DOCKET 50-255 - LICENSE DPR-20 -
PALISADES PLANT - SEP TOPICS III-6
AND III-11 - SEISMIC REVIEW

General comments on NUREG/CR-1833 "Seismic Review of the Palisades Nuclear Power Plant Unit 1 as part of the Systematic Evaluation Program". Manuscript completed December 15, 1980.

Response to Enclosure 2 of NRC letter of January 19, 1981.

1	7-30-80	LO	RMC	MMG	REVISE TITLE AND NOTE
0	6-20-80	LO	RMC	MMG	INITIAL RELEASE
REV	DATE	BY	CHK	APRV	DESCRIPTION
PALISADES NUCLEAR POWER PLANT AUXILIARY BUILDING					URS/JOHN A. BLUME & ASSOCIATES SAN FRANCISCO, CA.
FUEL OIL DAY TANK T25A & T25B					JOB NO. 8013 DWG NO. 10 SHT 1/1 REV 1

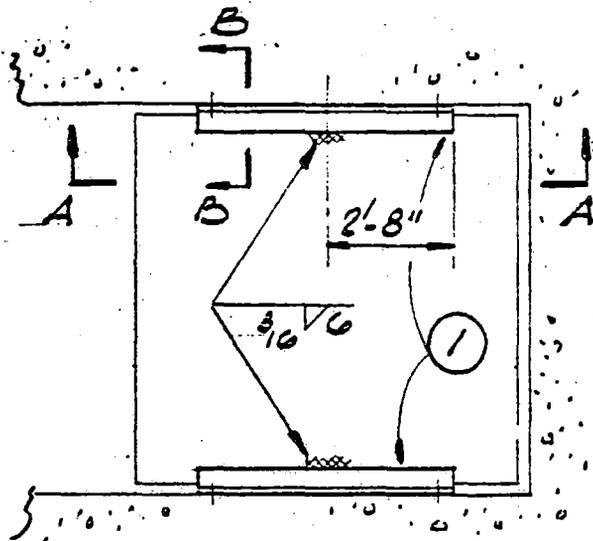
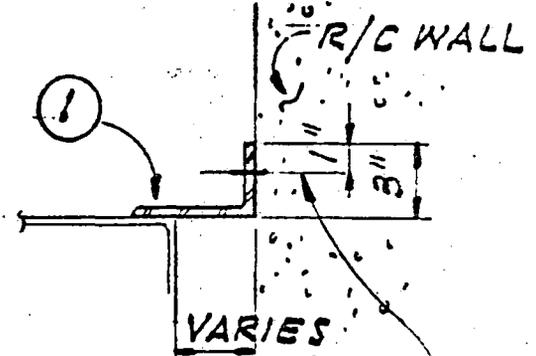
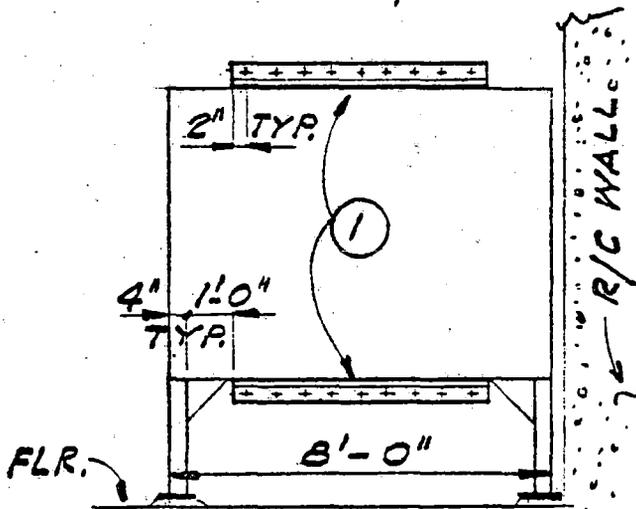
3. Diesel Generator Fuel Oil Tank (Day Tank) -
Provide Information on Seismic Design

The NUREG on page 99 indicated that the "Anchor-Bolt System for Flexible In-Structure Flat-Bottom Tanks may be overstressed if tank and fluid contents were assumed rigid in the original analysis". The supports for this tank were modified as a result of the equipment anchorage project triggered by NRC's January 1, 1980 letter. The new supports are shown on the attached drawing. They provide four point support off the reinforced concrete walls using heavy (7/16 inch thick) angle iron and 36 three-quarter inch anchor bolts which are rated at 2,400 lbs. each. The new anchorage is designed to resist a 1.6 g horizontal force (peak of the floor response) on the full tank while ignoring any restraint available

from the original anchorage system. Although no dynamic analysis was performed, the anchorage in its new configuration is unquestionably rigid. The basic concern in the NUREG has been taken care of by this modification. Since the contents of the tank (fuel oil) are clearly nonrigid, a sloshing and hydrostatic analysis will be performed to demonstrate that the tank walls will not buckle. Due to lack of a detailed drawing of the tank this is expected to take from 3 to 6 months.
